## Access Compliance Report Public Rights-of-Way (Curb Ramps)

Intersection ID: 12144 Main Street: ALLEGHANY\_ST Cross Street: WILKINSON\_BV Location: N

ADA ID: 8ACF206BF2F7 Ramp Type: Para Initial Pass/Fail: Fail Overall Compliance: No Severity Score: 21.25

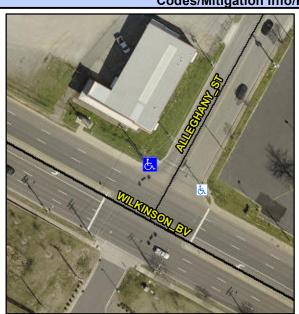
RT RP <5%

R304.5.1, R304.3.2

Compliance Description		Data	Compliance Description		Data
N/A	Ramp Length LT (in)	28.5	N/A	Ramp Length RT (in)	29.0
No	Ramp Width LT (in)	46.0	No	Ramp Width RT (in)	46.0
No	Ramp Slope LT (%)	11.4	Yes	Ramp Slope RT (%)	3.4
Yes	Ramp XSlope LT (%)	1.6	Yes	Ramp XSlope RT (%)	1.8
N/A	Landing Length (in)	N/A	N/A	DWS Provided?	N/A
N/A	Landing Width (in)	N/A	N/A	DWS Contrast?	N/A
N/A	Landing Slope (%)	N/A	N/A	DWS Length (in)	N/A
N/A	Landing X Slope (%)	N/A	N/A	DWS Full Width?	N/A
N/A	Landing Curb? (Y/N)	N/A	N/A	DWS Offset (in)	N/A
N/A	Shared Landing?	N/A			
N/A	Gutter Ponding?	N/A	N/A	Gutter Slope (%)	N/A
N/A	Gutter Lip Ht (in)	N/A	N/A	Gutter X Slope (%)	N/A
N/A	Painted X Walk1?	No	N/A	Painted X Walk2?	N/A
	X Walk 1 Direction	To SE		X Walk 2 Direction	N/A
N/A	X Walk 1 Width (in)	N/A	N/A	X Walk 2 Width (in)	N/A
	X Walk 1 Slope (%)	1.8		X Walk 2 Slope (%)	N/A
	X Walk 1 X Slope (%)	3.4		X Walk 2 X Slope (%)	N/A
N/A	Ramp inside XWalk1?	N/A	N/A	Ramp inside XWalk2?	N/A

Remove & Replace Entire Ramp.
